Access Compliance Report

Public Rights-of-Way

(Curb Ramps)

Intersection ID: N/A	Main Street: AMBROSIA_ST	Cross Street: N/A	Location: S
ADA ID: 4DCE8EE6FB02	Ramp Type: Perp	Initial Pass/Fail: Fail	Overall Compliance: No
Severity Score: 26.25			
Codes/Mitigation Info/Possible Solution		Field Measurements/Component Compliance

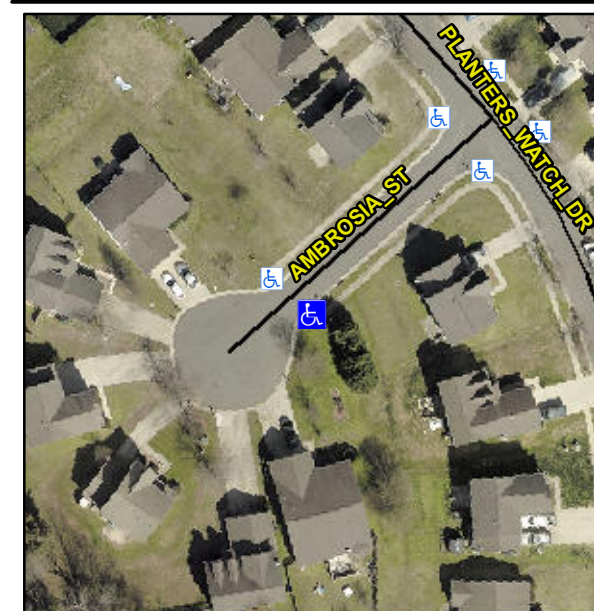
Not Found, R304.2.2

Compliance	Description	Data	Compliance	Description	Data
N/A	Ramp Length (in)	48.0	No	Ramp Slope (%)	12.9
Yes	Ramp Width (in)	51.0	Yes	Ramp XSlope (%)	4.7
N/A	Flare Type LT	N/A	N/A	Flare Type RT	N/A
N/A	Flare Slope LT (%)	N/A	N/A	Flare Slope RT (%)	N/A
N/A	Flare Traversable LT?	N/A	N/A	Flare Traversable RT?	N/A
N/A	Landing Length (in)	N/A	N/A	DWS Provided?	N/A
N/A	Landing Width (in)	N/A	N/A	DWS Contrast?	N/A
N/A	Landing Slope (%)	N/A	N/A	DWS Length (in)	N/A
N/A	Landing X Slope (%)	N/A	N/A	DWS Full Width?	N/A
N/A	Landing Curb? (Y/N)	N/A	N/A	DWS Offset (in)	N/A
N/A	Shared Landing?	N/A			
N/A	Gutter Ponding?	N/A	N/A	Gutter Slope (%)	N/A
N/A	Gutter Lip Ht (in)	N/A	N/A	Gutter X Slope (%)	N/A
N/A	Painted X Walk1?	No	N/A	Painted X Walk2?	N/A
	X Walk 1 Direction	To NW		X Walk 2 Direction	N/A
N/A	X Walk 1 Width (in)	N/A	N/A	X Walk 2 Width (in)	N/A
	X Walk 1 Slope (%)	1.1		X Walk 2 Slope (%)	N/A
	X Walk 1 X Slope (%)	5.1		X Walk 2 X Slope (%)	N/A

Remove & Replace Entire Ramp.
